PERMIT MODIFICATION REQUEST
(VOLUME II OF II)
Reconfiguration of Block O

City of Nacogdoches Landfill
Nacogdoches, Texas
TCEQ Permit No. MSW-720

File No. 16209006.26 | January 2024

Attachment No. 6
Redline/Strikeout Pages

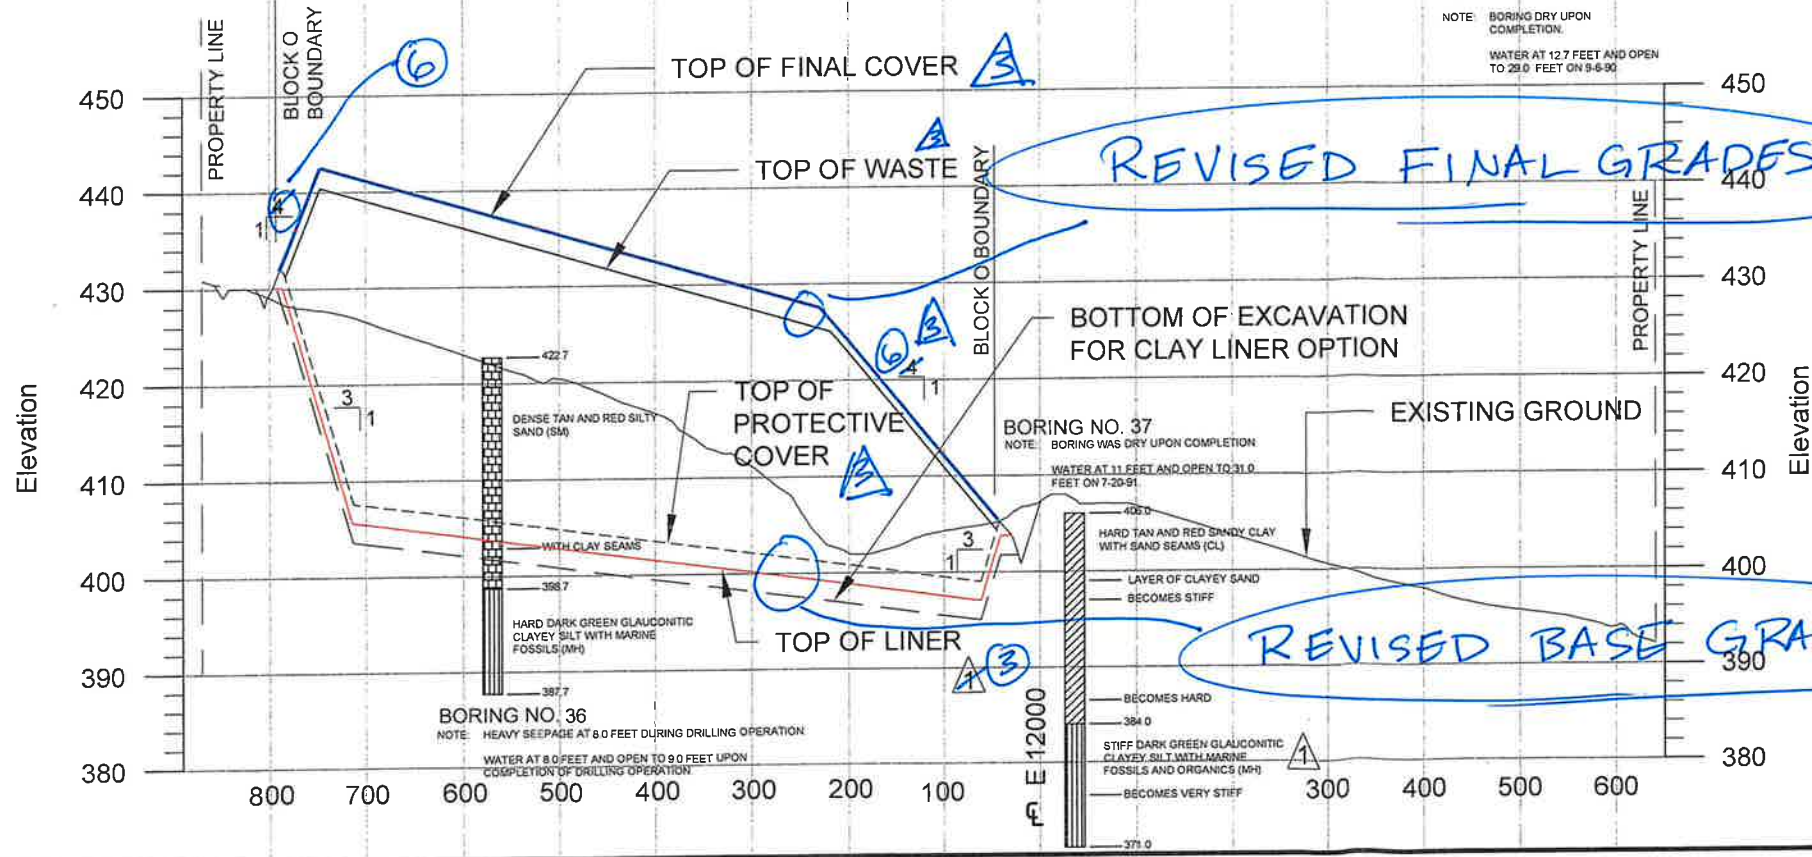
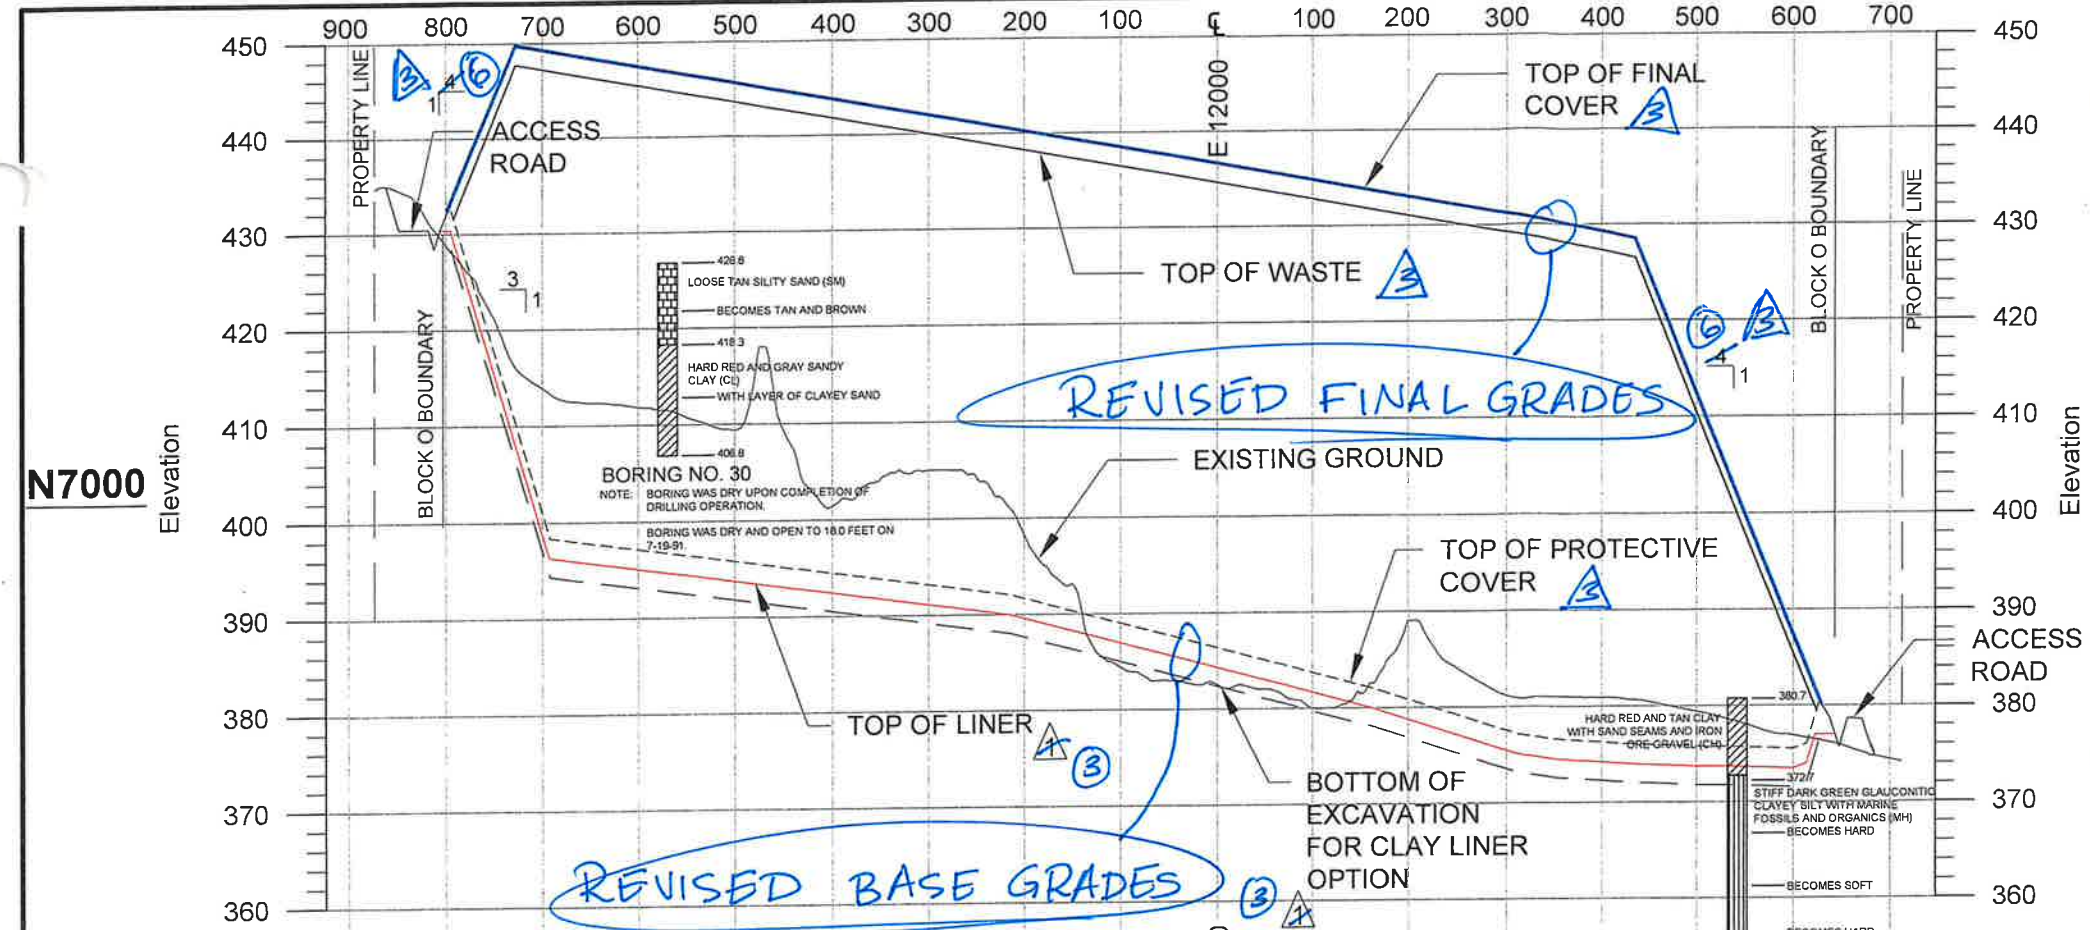
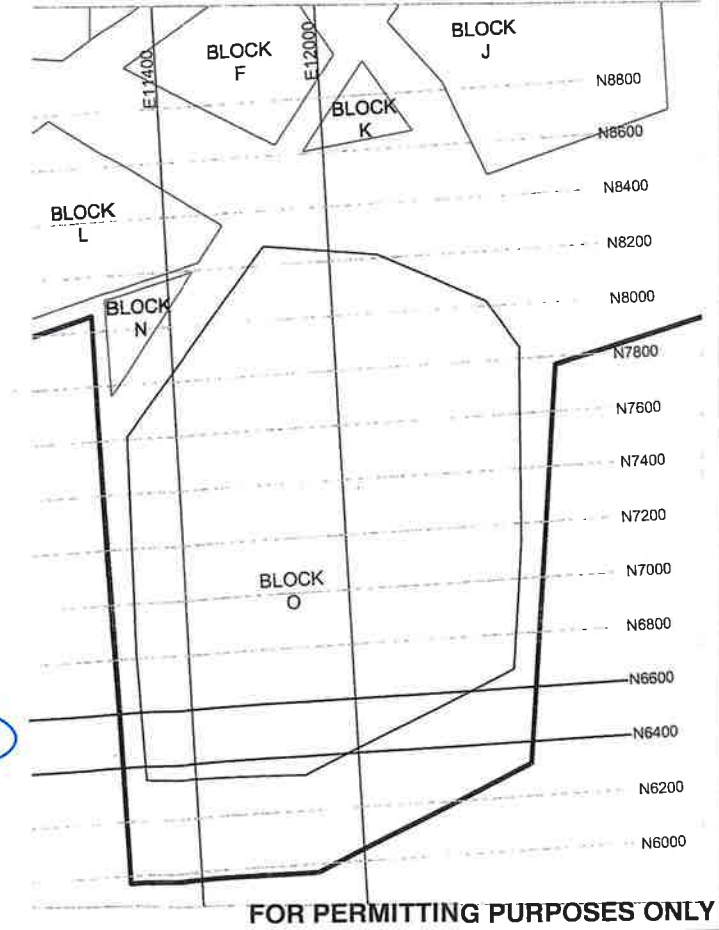
REVISOR'S NOTE: REVISED BASE AND FINAL COVER GRADES 12/2023 SCS

③ REVISED BASE AND FINAL COVER GRADES
 12/2023 SCS

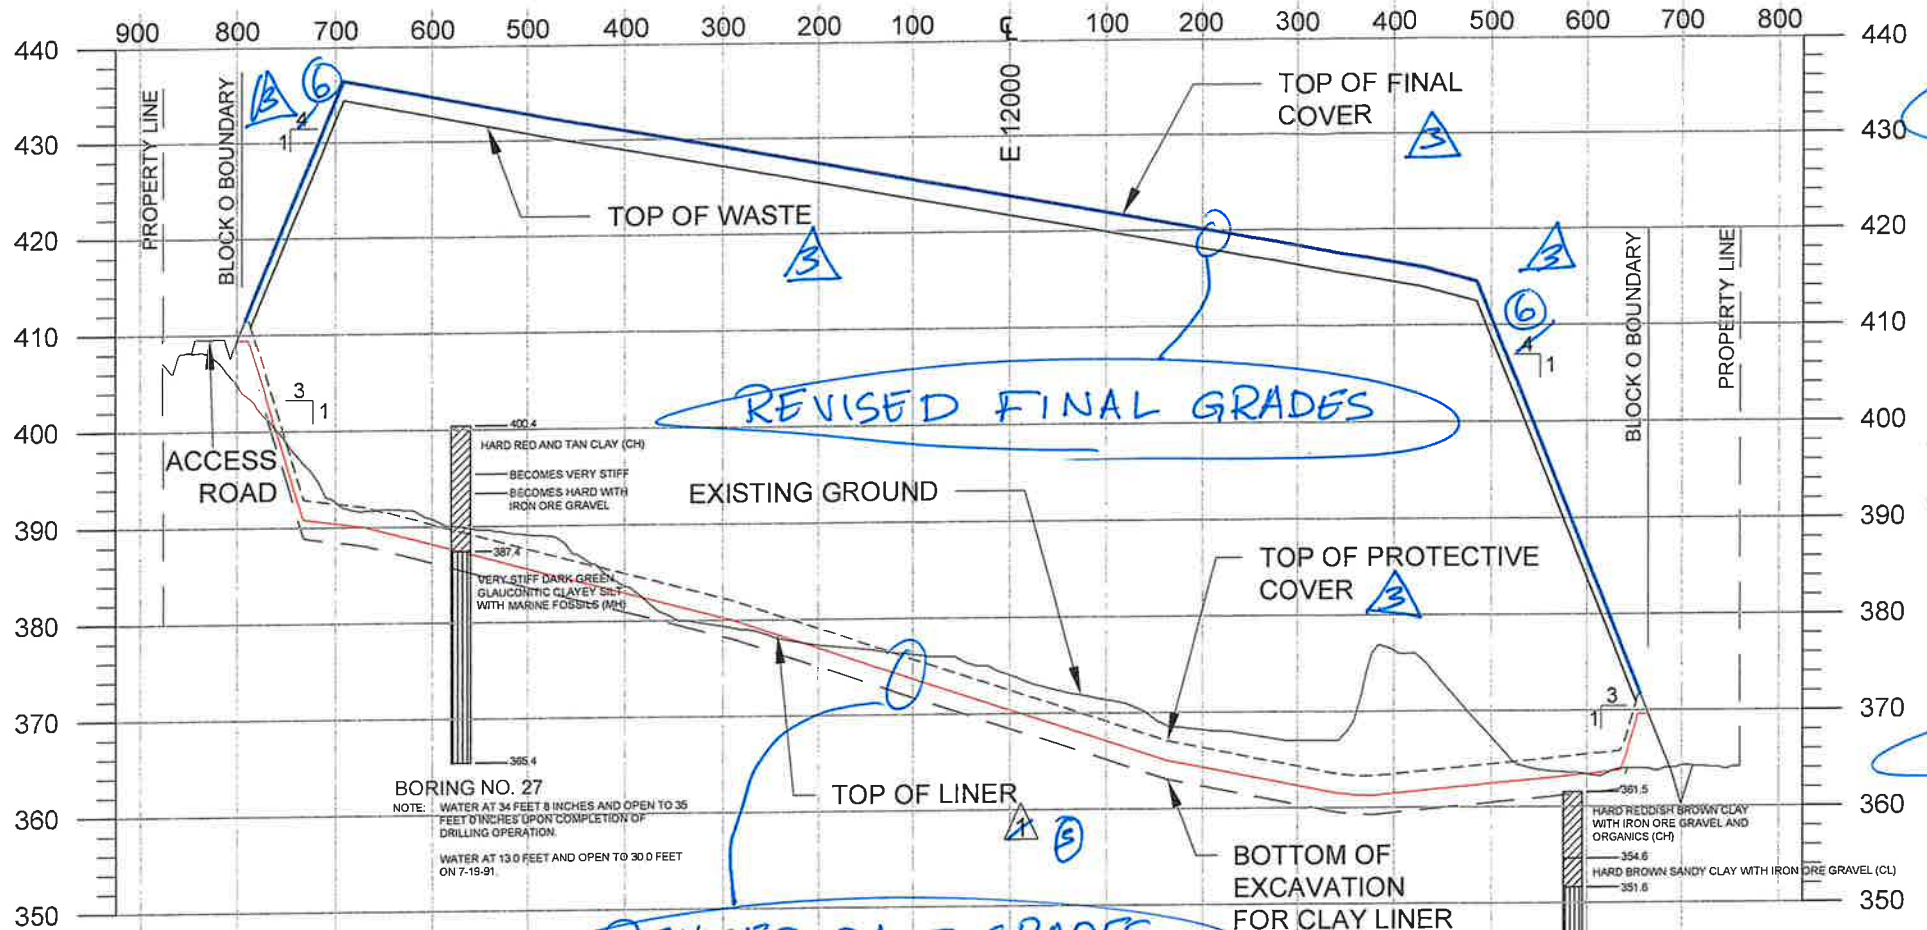
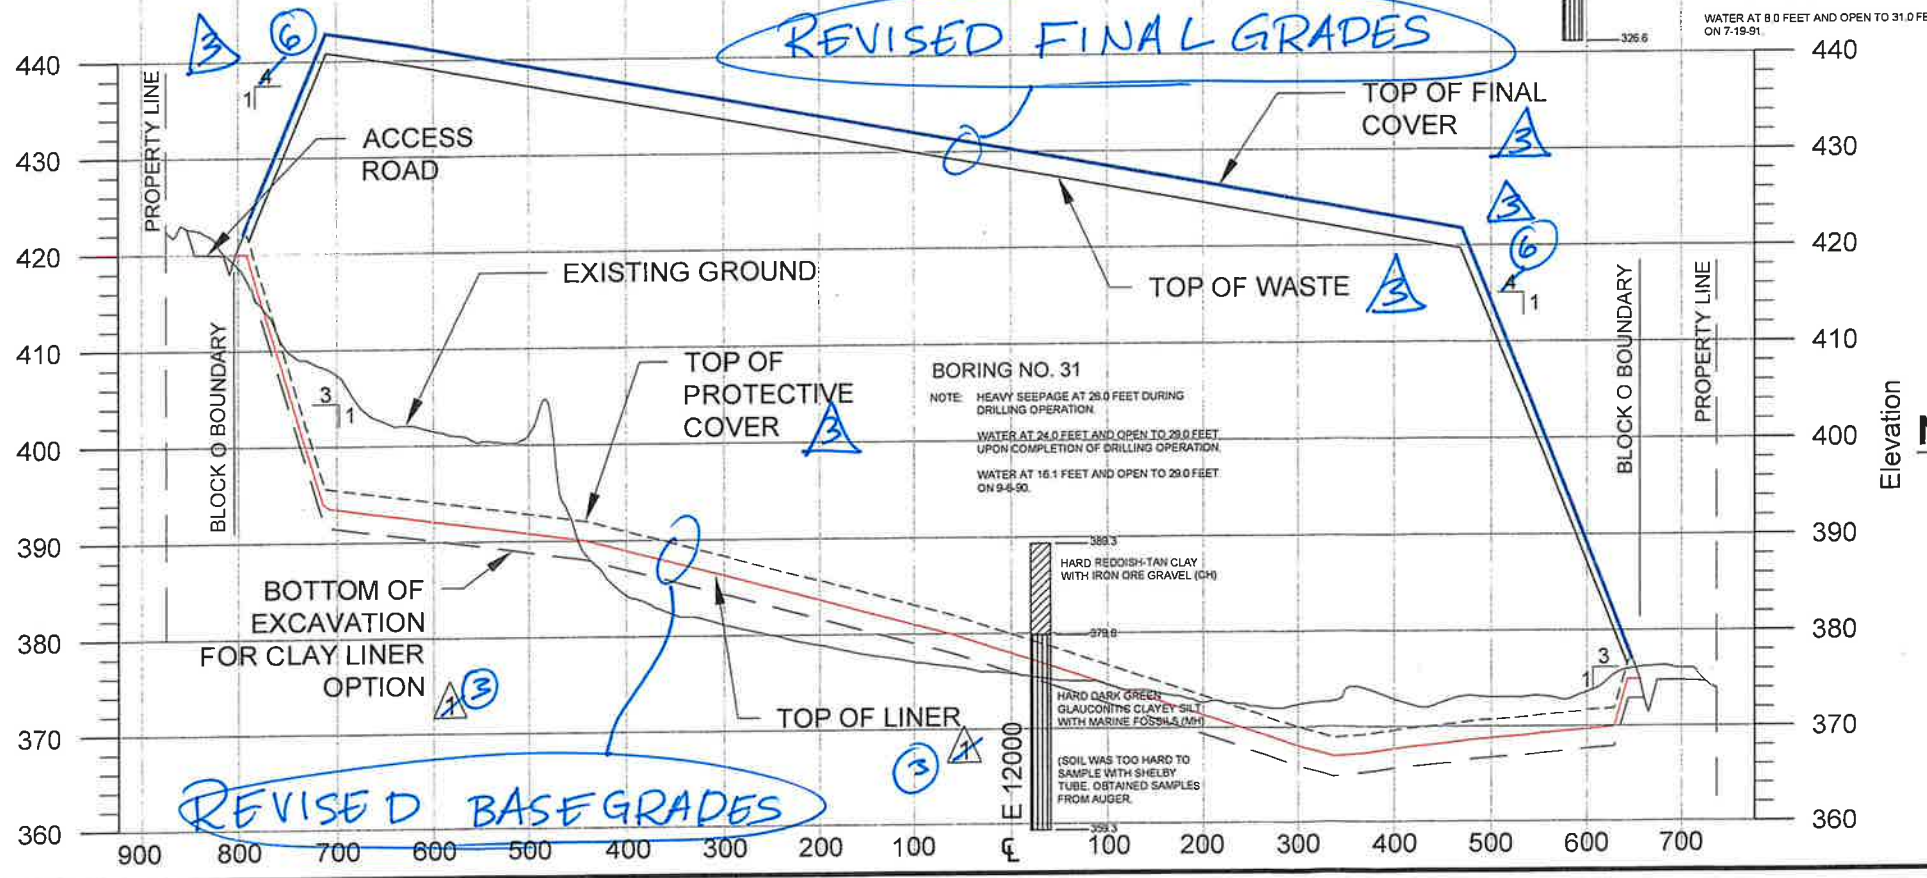
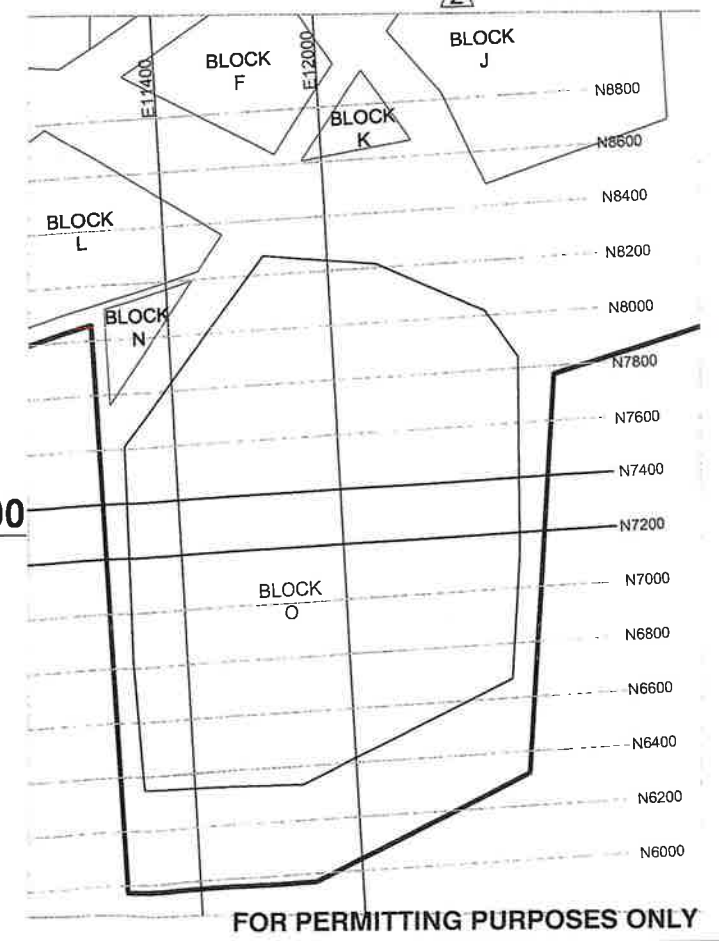
12/2023 REVISED BASE AND FINAL GRADES
